## TECHNICAL MEMORANDUM

**DATE:** 9/14/07  
**TO:** Mayor Scott Harbertson, Farmington City  
Members of the Farmington City Council  
Members of the Farmington Planning Commission  
**FROM:** Timothy Taylor, PE, PTOE  
**RE:** LEGACY NORTH TO LEGACY CONNECTION EVALUATION STUDY

The purpose of this technical memorandum is to summarize findings and recommendations related to the Legacy North to Legacy Connection Evaluation Study.

Figure C1: UDOT Corridor Preservation Option 1

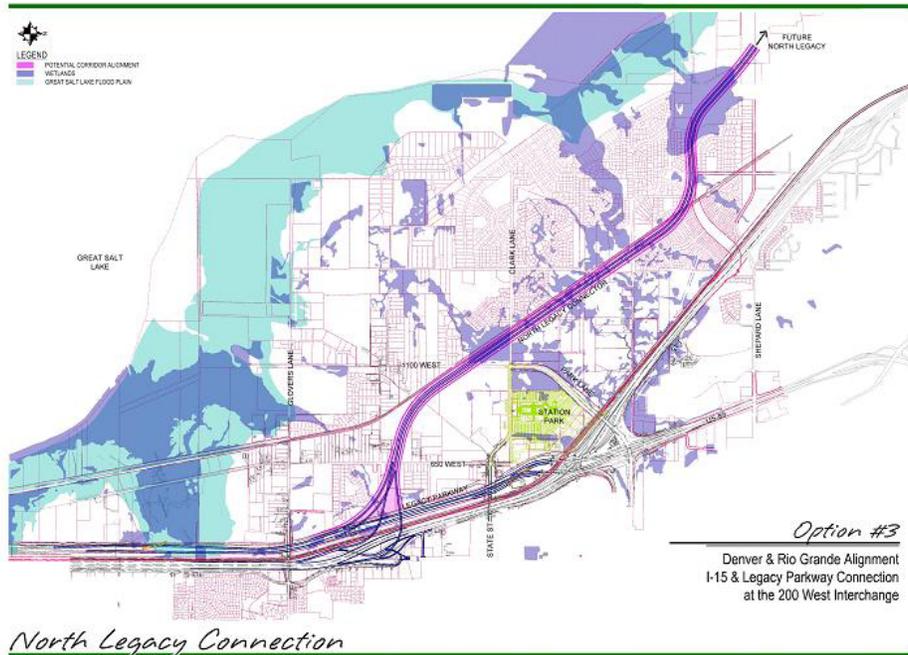
Figures C1 through C4 depict each of the UDOT options. Table C1 presents a summary of general pros and cons of each UDOT option as well as the current master transportation plan option. These pros and cons were developed based on asking the question, "Which option is best for Farmington City."

In looking at pros and cons, each option has either a substantial con or requires further study in order to conclude that the particular option is indeed "better" than the others or the "best" for the City. The preparation of an environmental document would likely assist in providing answers to many of the technical questions but would not help in making decisions on items that are goal oriented or value based.

*Based on the lack of technical information provided in the UDOT Corridor Preservation Study, we recommend that the City wait to consider UDOT's request to amend the Master Transportation Plan to include a preservation corridor until UDOT completes an Environmental Assessment (EA) or Environmental Impact Statement (EIS).*

Figure E1 depicts the four UDOT options as well as additional corridor options that were considered.

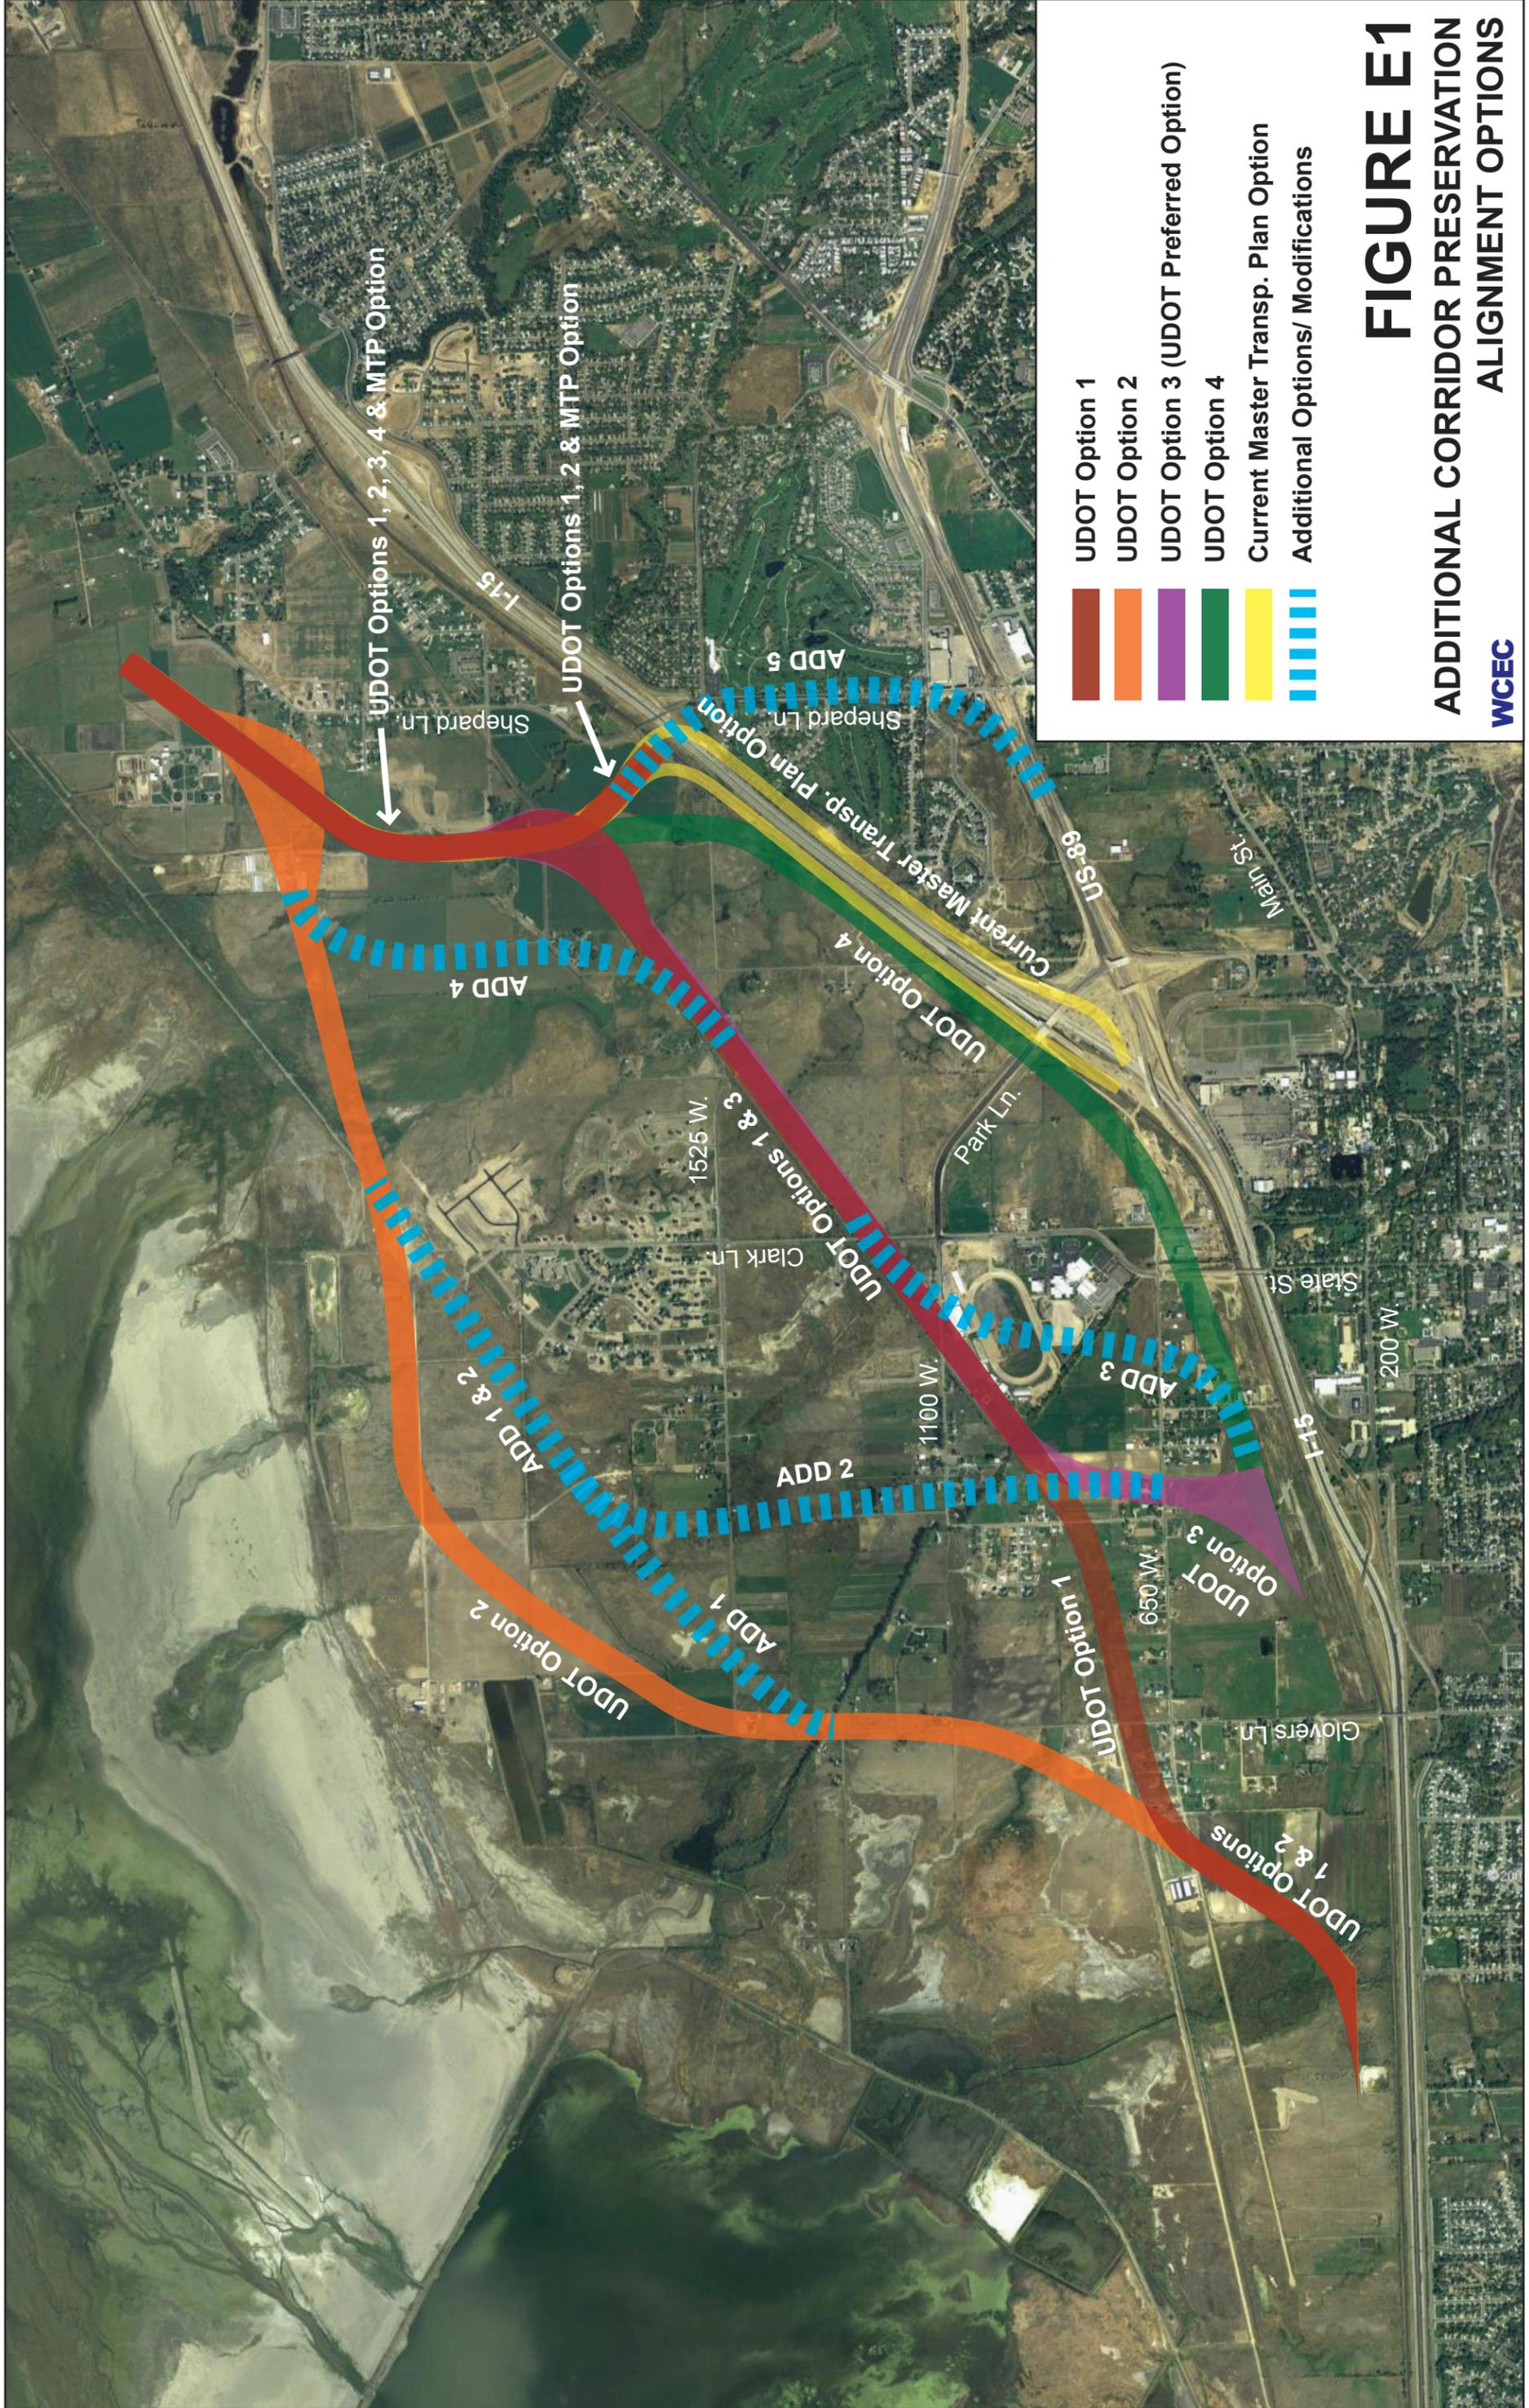
Based on our review of the process followed by Horrocks Engineers to identify preservation corridor options as a part of the UDOT Study, a full range of viable options was considered.

Our independent identification of additional options resulted only in modifications to or combinations of one or more of the four UDOT options. Although some of the additional options represented a perceived improvement as compared to the original option, none proved to address the primary issues of concern or resulted in the elimination of relevant questions better than any other option.
